SERVICE BULLETIN

ENGINE - HP TURBINE - INCORPORATE AN IMPROVED TURBINE LOCK - CATEGORY CODE 5 -
MOD.ENG-72-0076

V2500-ENG-72-0076

Location of HP Turbine Hub Lock
Fig.1

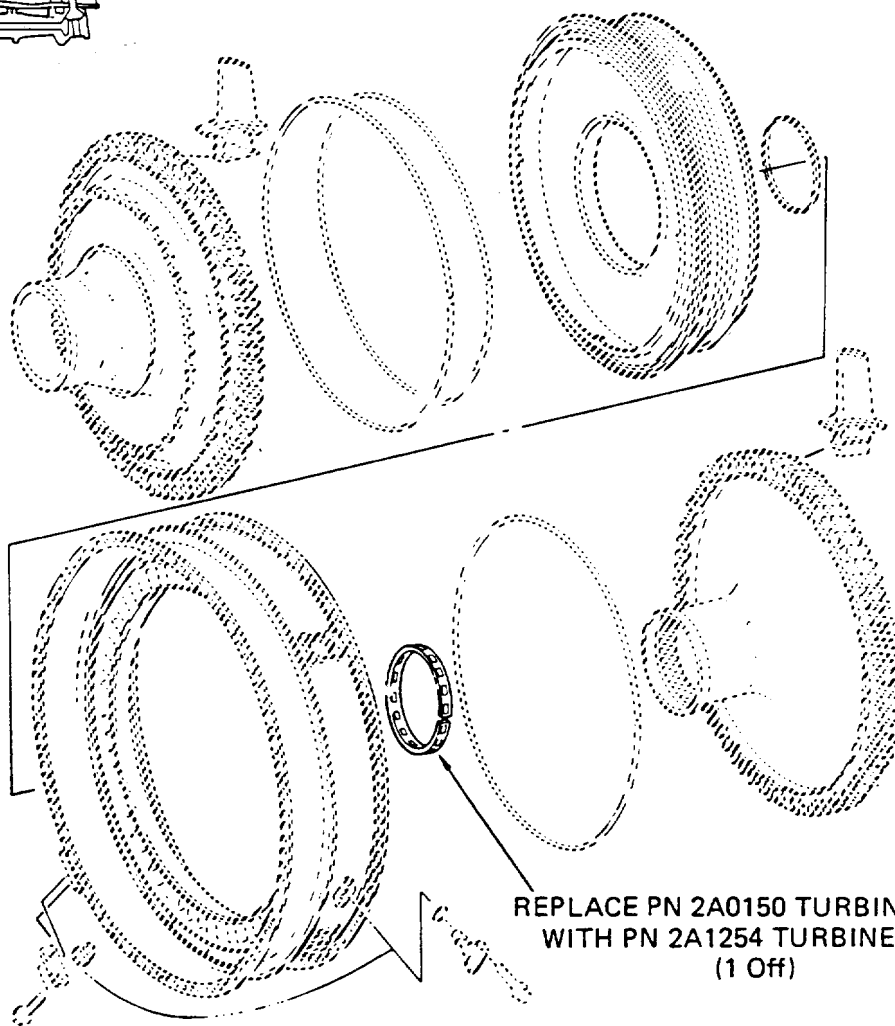
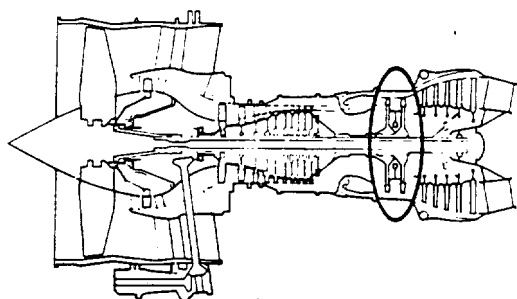
- (1) Replace the Turbine Hub Lock with a new lock that features a more stringent dimensioning of the first slot.

- (1) Remove 2A0150 Turbine Hub Lock by the approved procedures in Reference (1), Chapter/Section 72-45-00 Disassembly. See Figure 1.

- (1) Install 2A1254 Turbine Hub Lock (1 off) by the approved procedures in Reference (1), Chapter/Section 72-45-00 Assembly. See Figure 1.
